# PLANNING COMMITTEE

**5. 22/1764/FUL - WORLD OF WATER, HEMPSTEAD ROAD, WATFORD, HERTFORDSHIRE, WD4 8QG**

Demolition of existing building and erection of retail food store, (Use Class E(a)), with associated access, parking and amenities.

site highway impacts that would warrant a reason for refusal particularly in light of the NPPF.

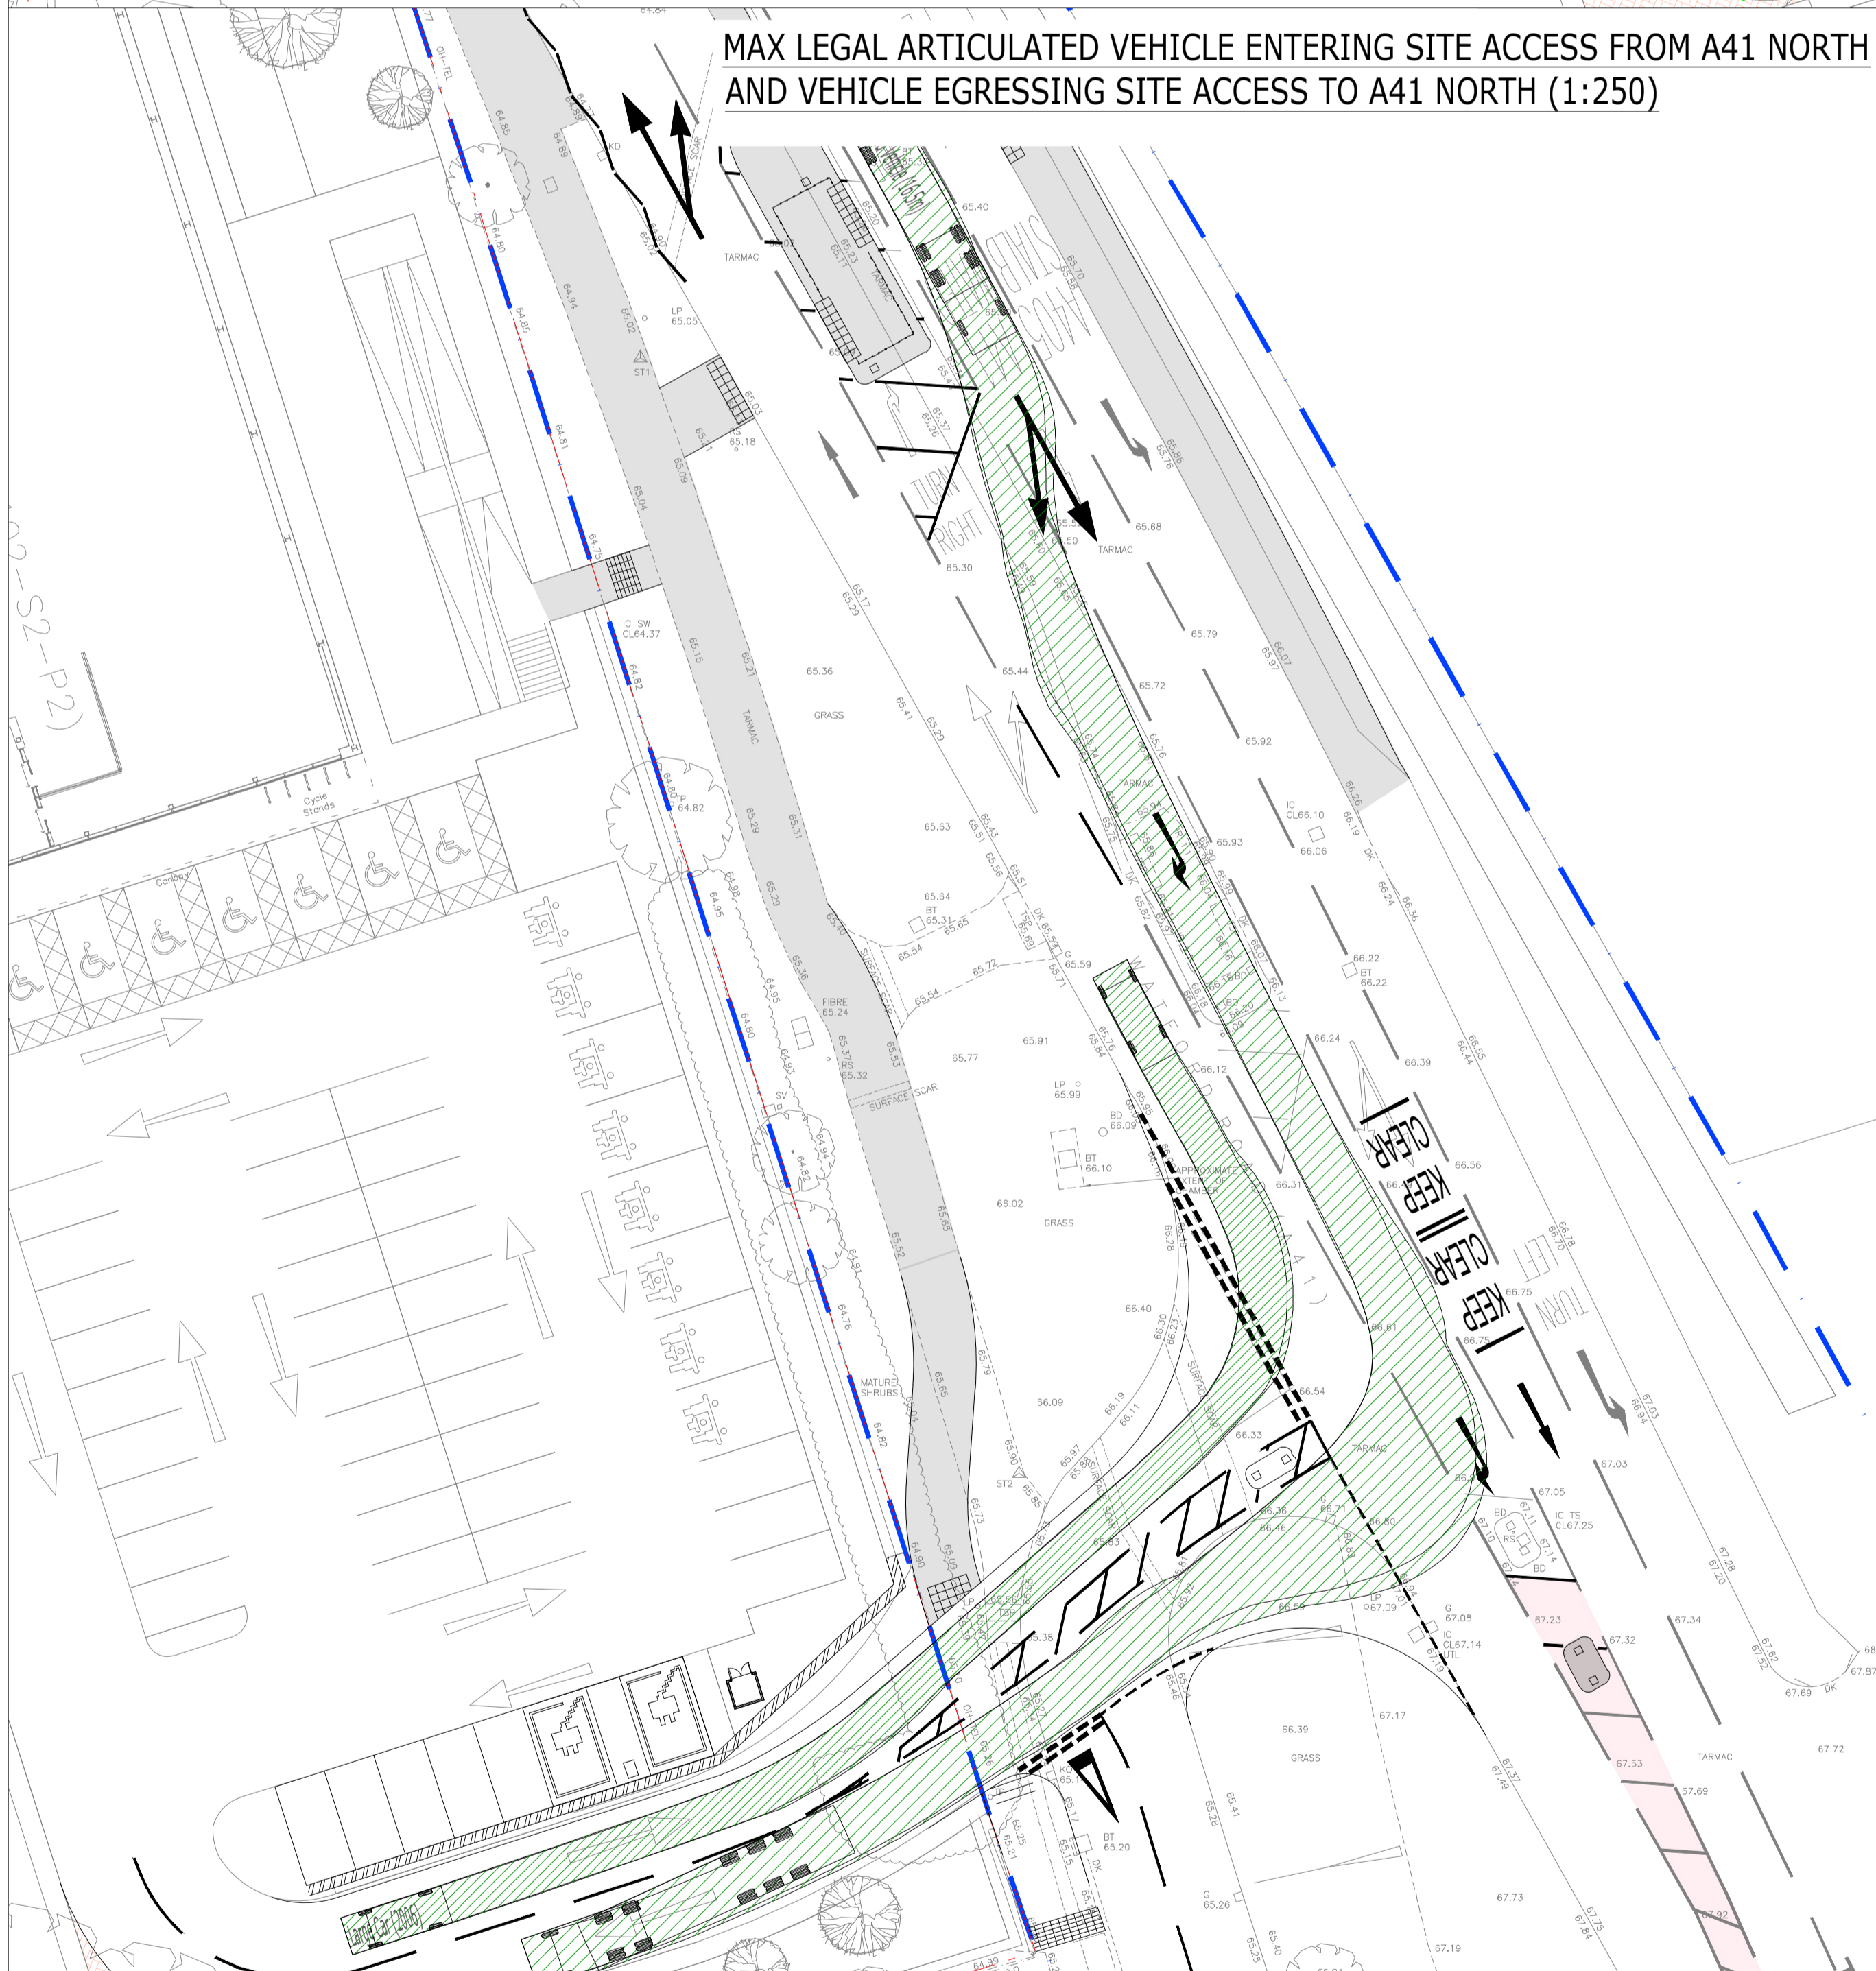
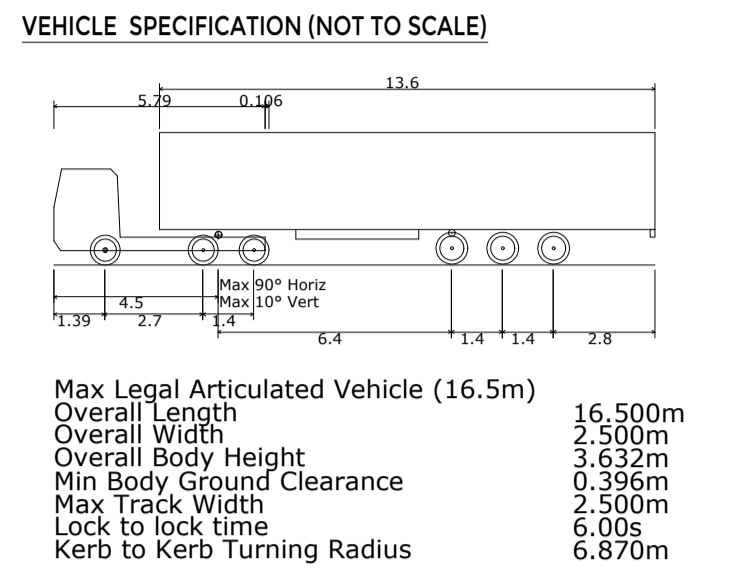
- 2.8 Notwithstanding the above, **ACE Drawing 187011-001J** has been updated to demonstrate how a 15m taper length could be provided (in line with CD 123 Table 5.22) for a 40mph speed limit, to alleviate the above concerns without significant impact on the proposed arrangement or requirement for additional modelling. The implementation of this increased direct taper would not have any significant impact on the proposed arrangement and should therefore not warrant refusal of the scheme. It is envisaged that this could be incorporated at detailed design stage, but the updated drawing included within this TTN should give confidence to the Committee that this can be delivered without significant impact on the overall operation of the junction.

2.62 In light of the above, **ACE Drawing 187011-001J** has been updated to demonstrate how a longer stagger of 1.8m on the island could be provided to ensure that cyclists could safely manoeuvre through the stagger. At this stage of the process, it is envisaged that this would be implemented and investigated further at detailed design stage. Though at this stage, should alleviate the concerns raised by the independent highways review by demonstrating that this minor amendment could be implemented if deemed as a requirement.
